CHICAGO PLAN COMMISSION

ELAM PLACE CONDOMINIUMS

3006 – 3012 East 78th. Street / 7th Ward / Ald. Greg Mitchell

SUMMARY OF COMMENTS

FIGURE 6
TYPICAL DRIVEWAY LAYOUTS

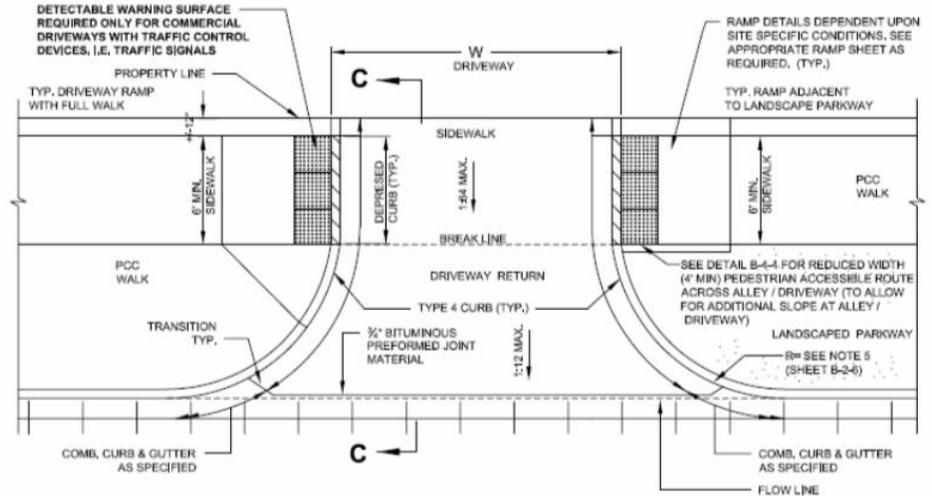
- VIII. Try to reduce width of access drive to lessen impact to on-street parking: (Design shows 19'5"W at property line) The flare type driveway (refer to following page for typical CDOT design) provides the narrowest of the two designs and we are holding the flares to the minimum 3FT – well below the 25'W maximum. The minimum two-way driveway width for a Residential parking lot over six cars in capacity is 20 feet (*City of Chicago Street and Site Plan Design Standards, p19*) (see page 11)

COMMENT H
Curb CUT haws been
reduced to minimal
CDOT standards

78th Street view from the East

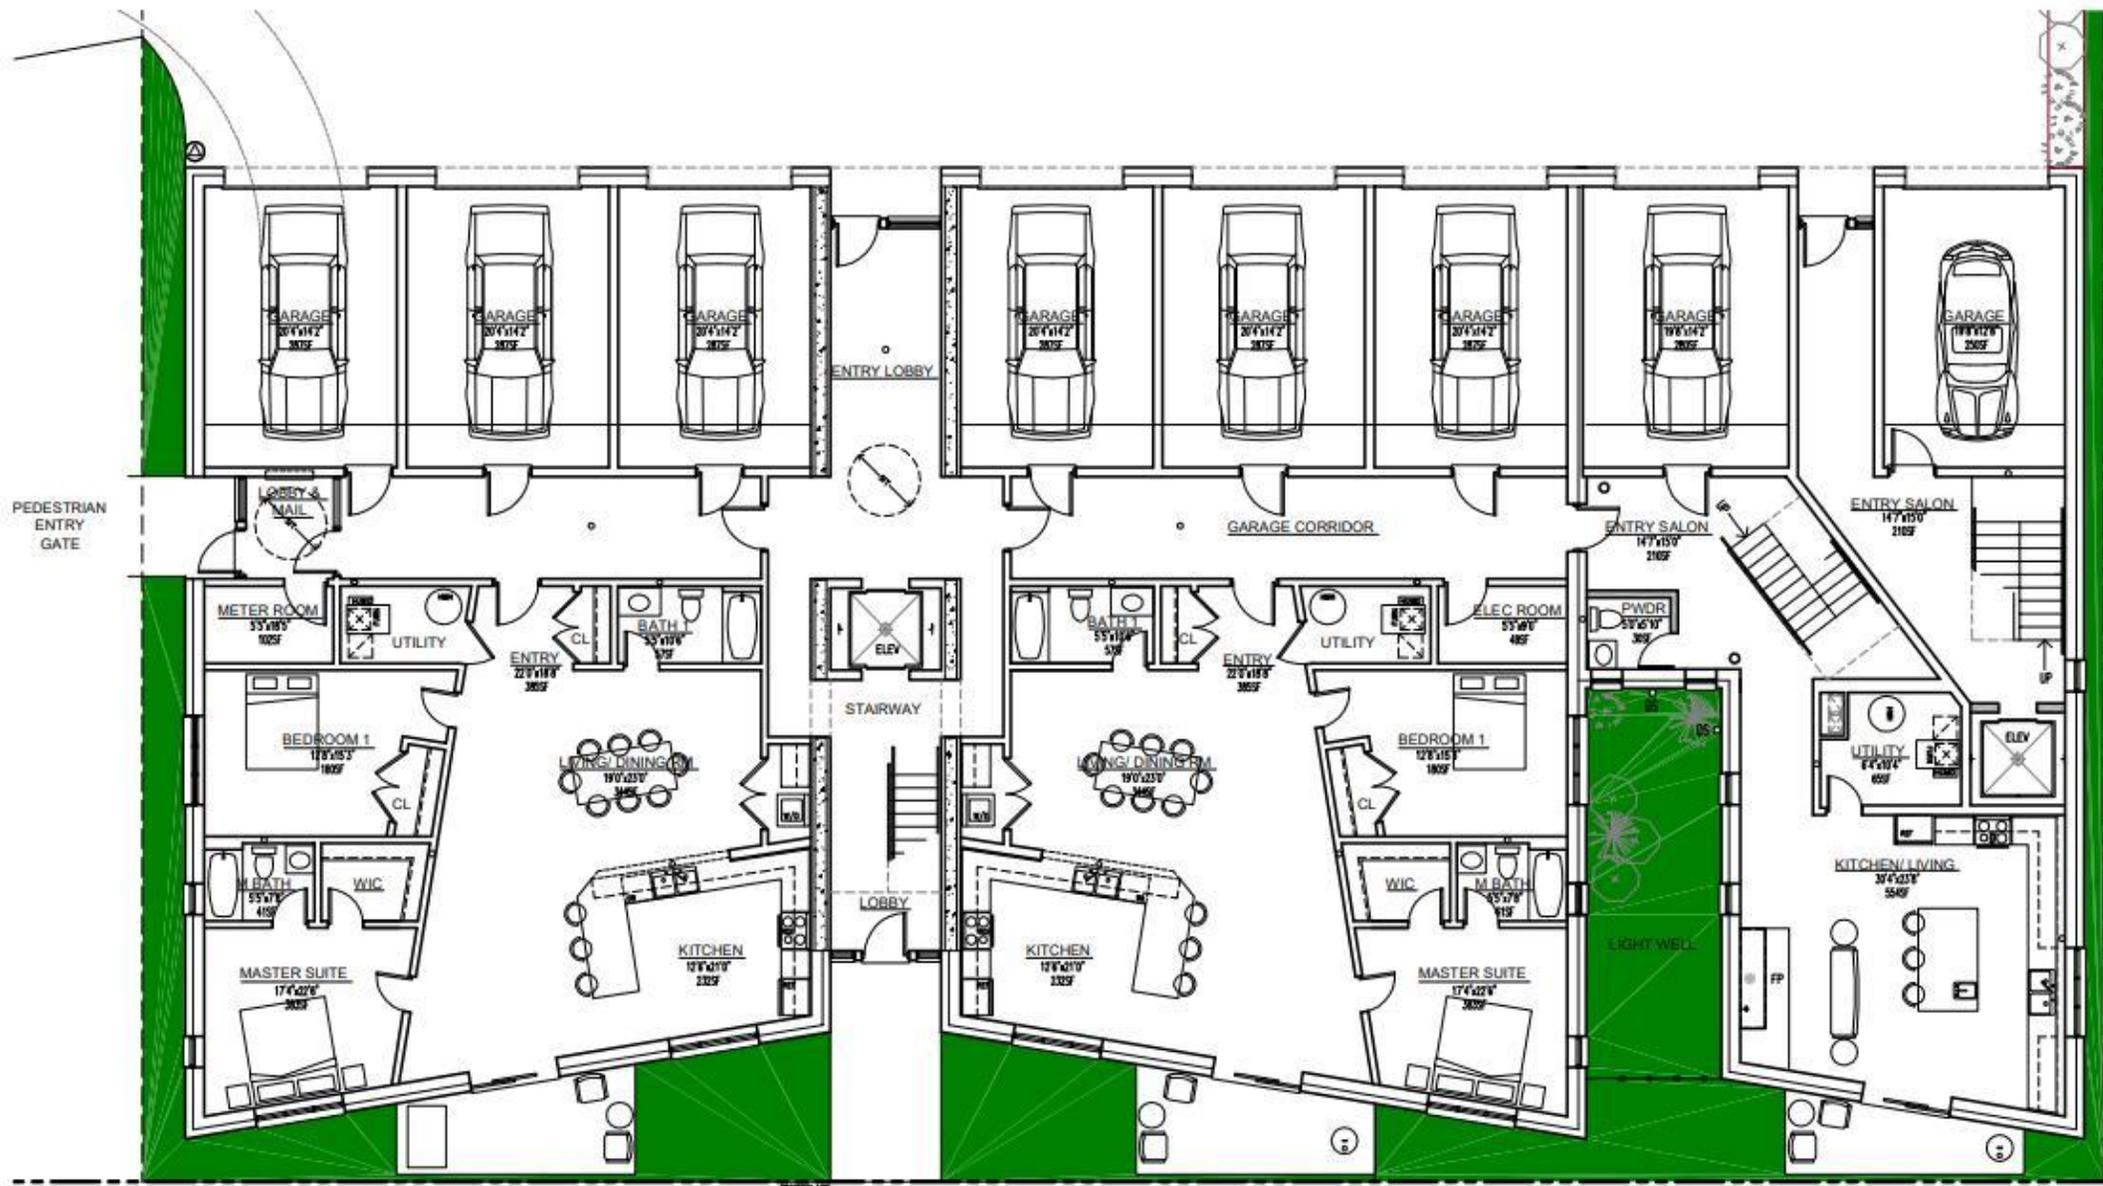
- X. Add pedestrian street view looking East (pages 18–19)

FLOOR PLAN – Ground

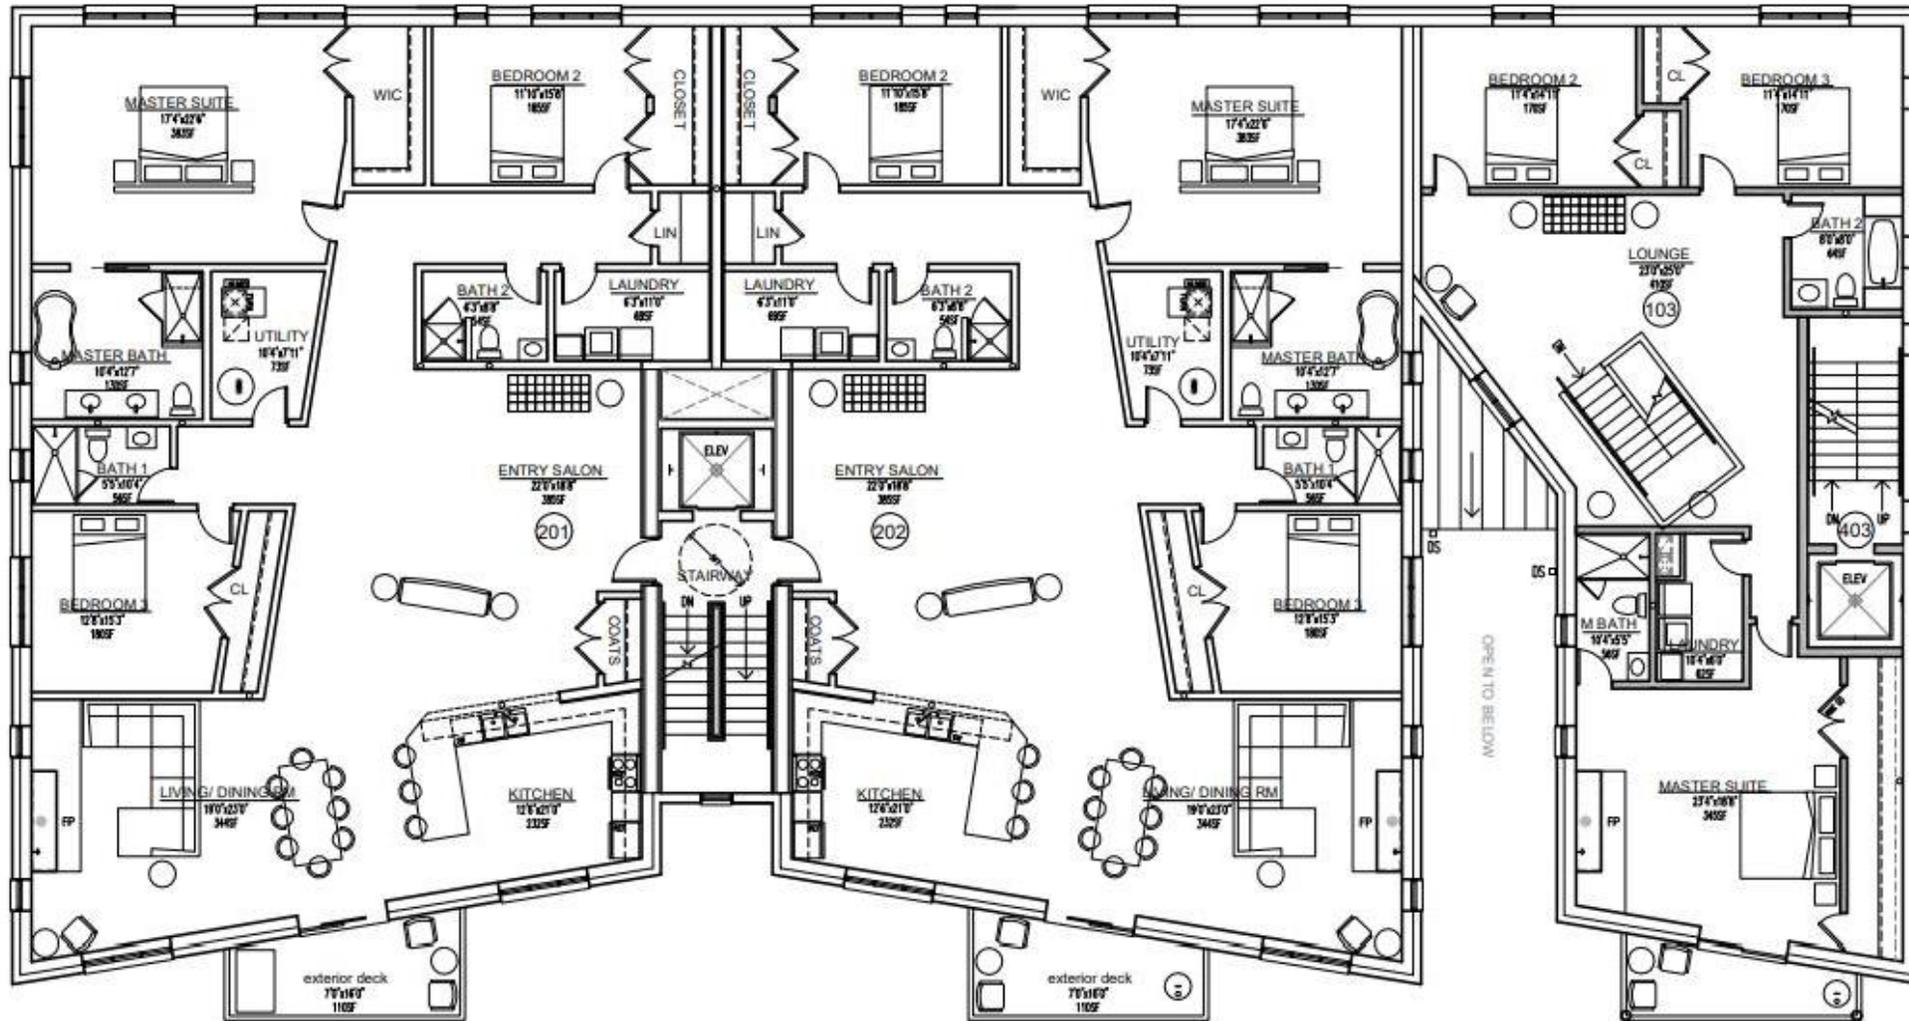
- III. Recess vestibule on 78th Street: The attached Ground Floor Plan reflects a recessed vestibule closer to the minimum clearance requirements for accessibility (per attached IAC figure 26) and turning radius for wheelchairs. Also, low-maintenance grass has been noted. (see page 25)

- IV. Change blue metal siding on exterior upper floor walls to masonry. (see page 40)
- V. Flip stairs at Owner's Unit: This is not feasible – this would pinch the corridor to 2'-8" clear. Conversely, when an Occupant walks 'under' the stairway in the current configuration the stairs will be 10'-0" above the floor at the Ground Floor corridor. (see page 25)

- FLOOR DATA:**
- 7,575 GSF FLOOR LEVEL
 - EIGHT-(8) PRIVATE ATTACHED GARAGES
 - SECURE LOBBY & STAIRWELL
 - TWO-(2), TWO-(2) BEDROOM GROUND LEVEL UNITS
 - GROUND LEVEL OF DUPLEXED UNIT
 - ENTRY FOR OWNER UNIT
 - LIGHTWELL TO ALLOW FOR MORE NATURAL LIGHT INTO UNITS
 - LOW-MAINTENANCE GRASS AT GROUND LEVEL
 - RECESSED ENTRIES
 - FLIPPING OWNER UNIT STAIRS WOULD CREATE A NARROW PINCH POINT (2'-8")

BUILDING ELEVATION - NORTH (LIGHT WELL)

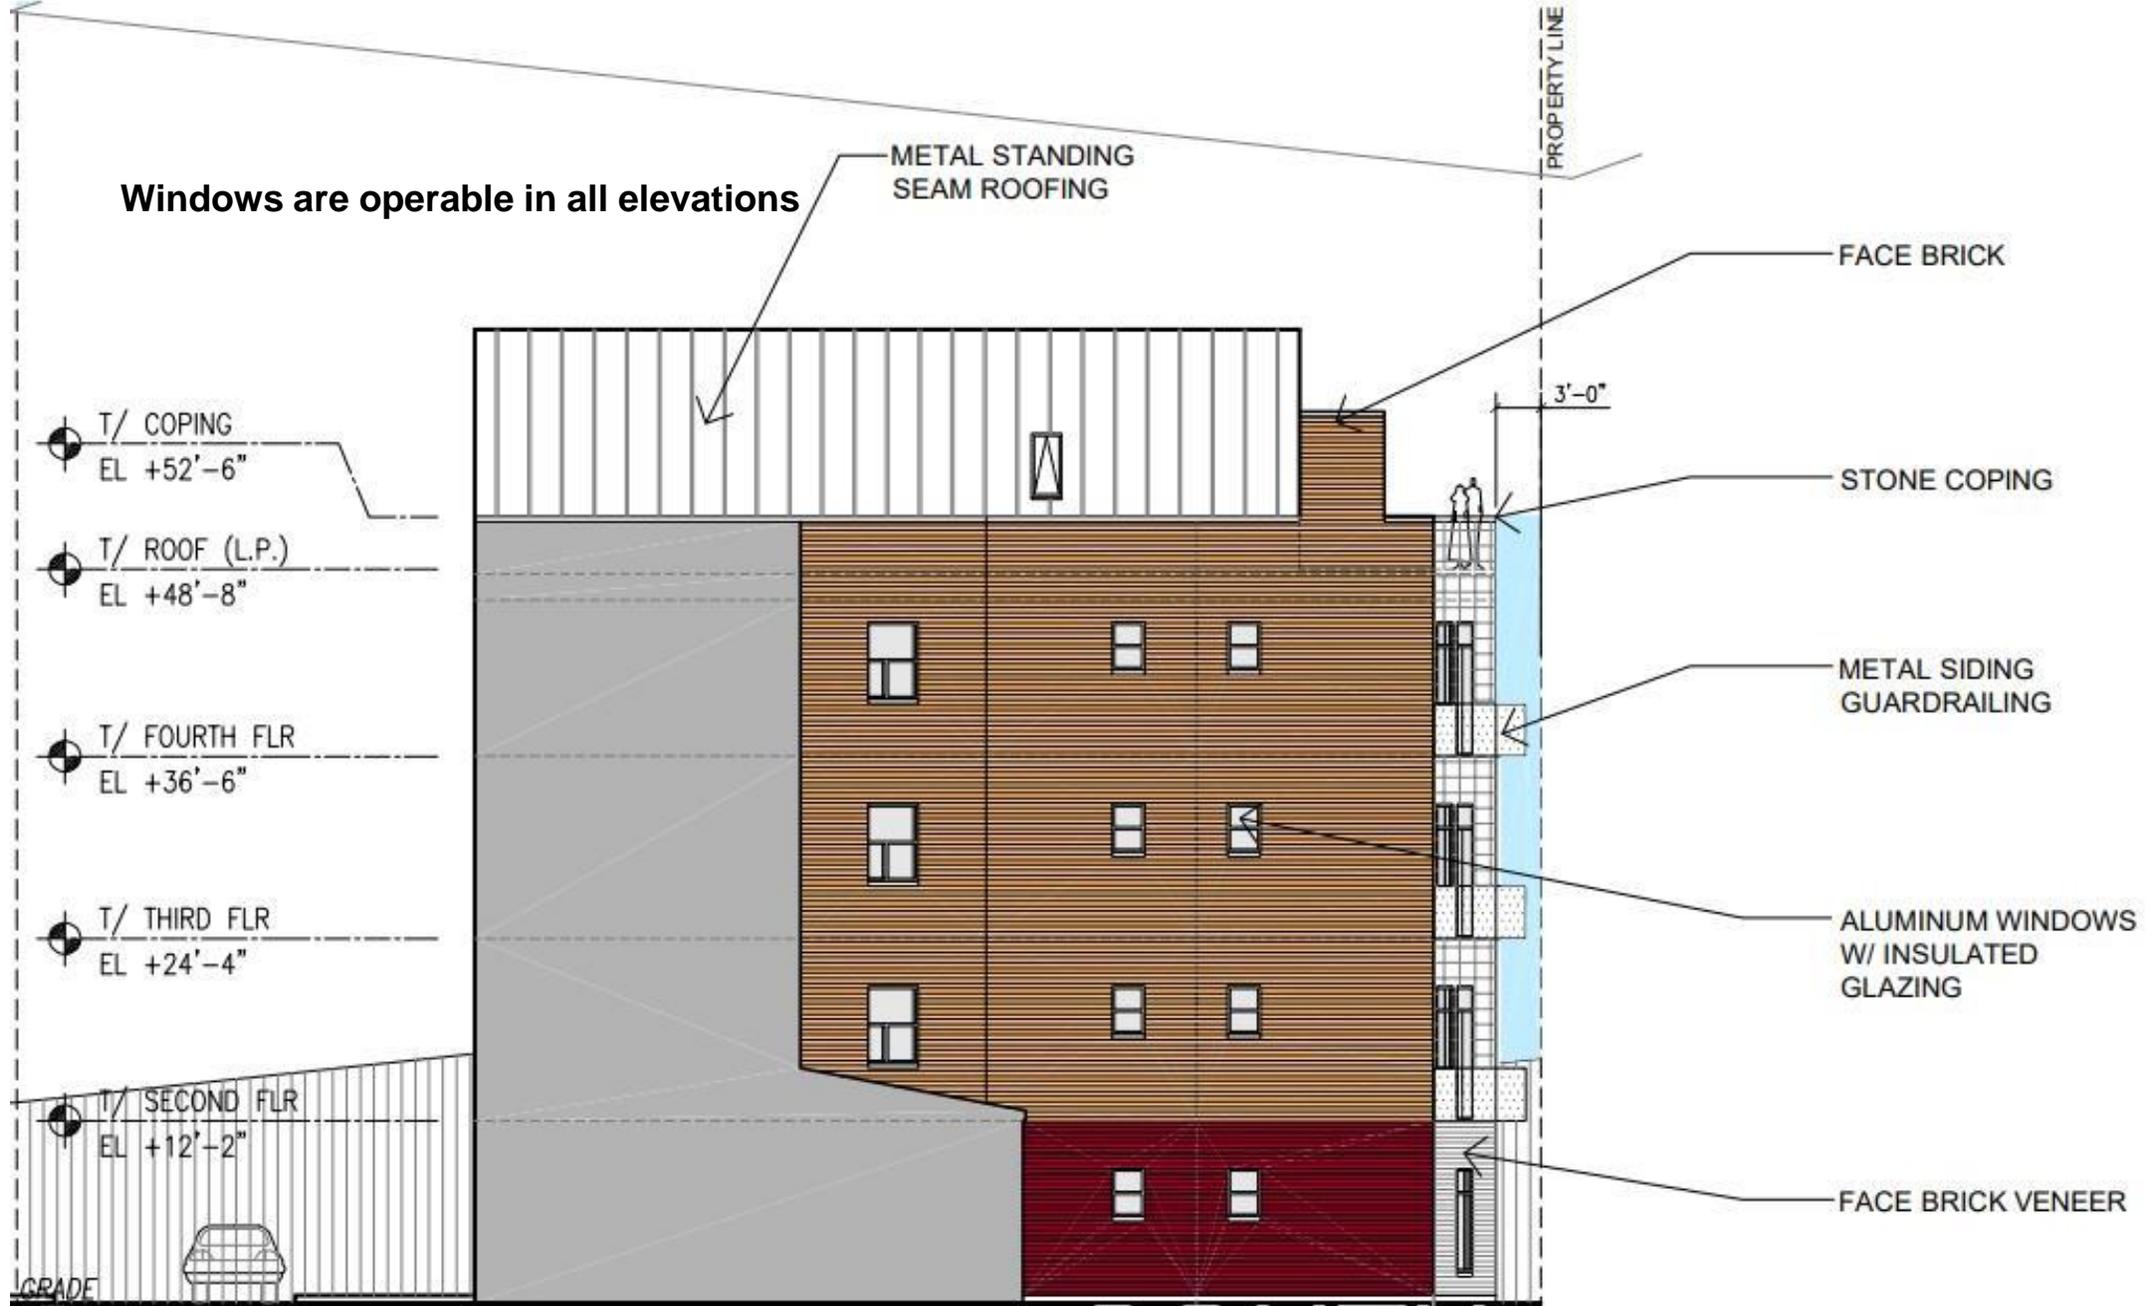
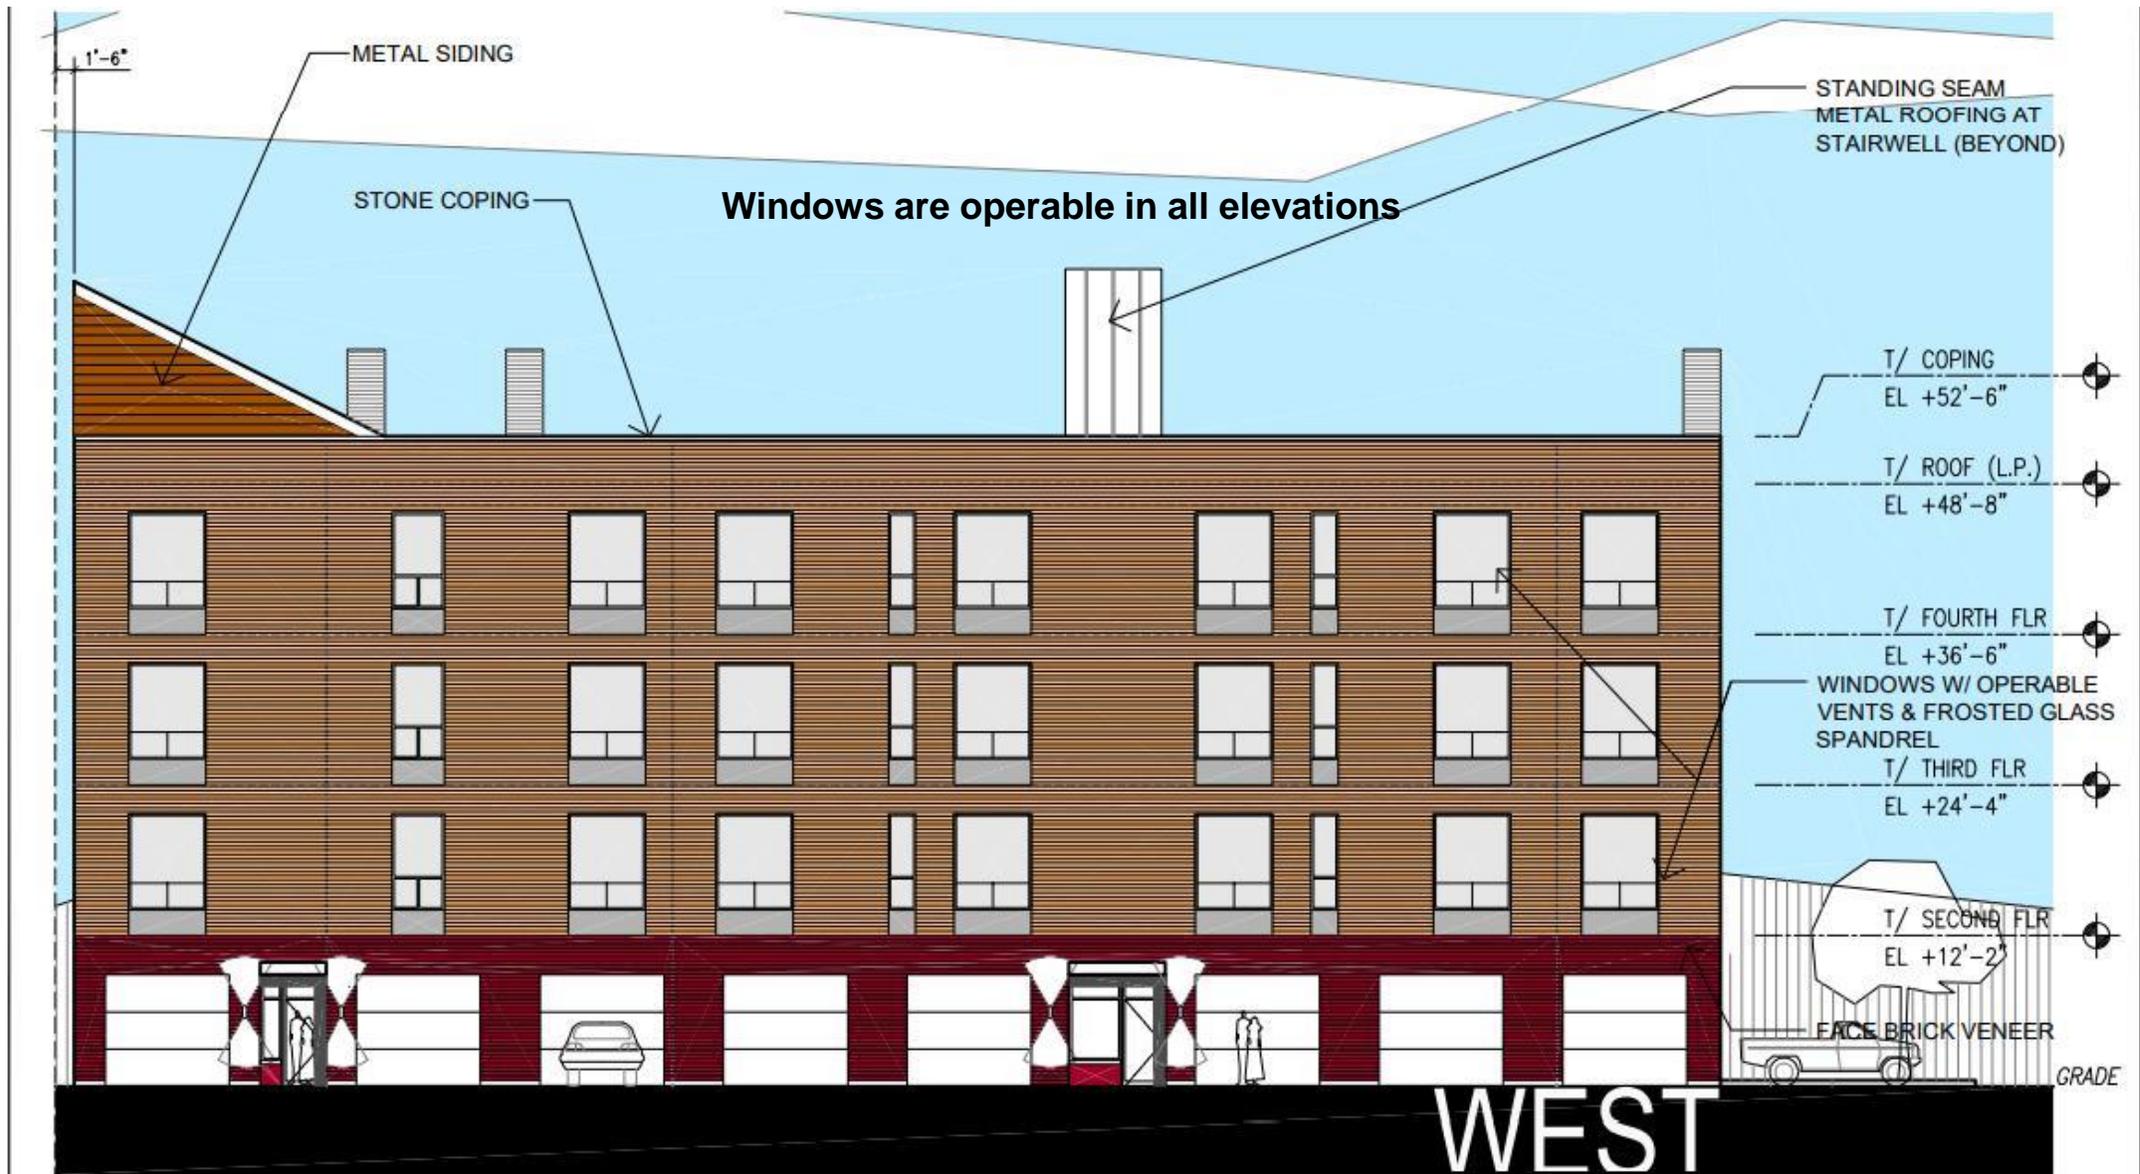
- VI. Operable windows at all elevations. (see pages 30–35)
- VII. Previous vertical design flare with tall chimneys changed. Chimneys were reduced in height by more than half. (4'-0" tall now)

Windows are operable in all elevations
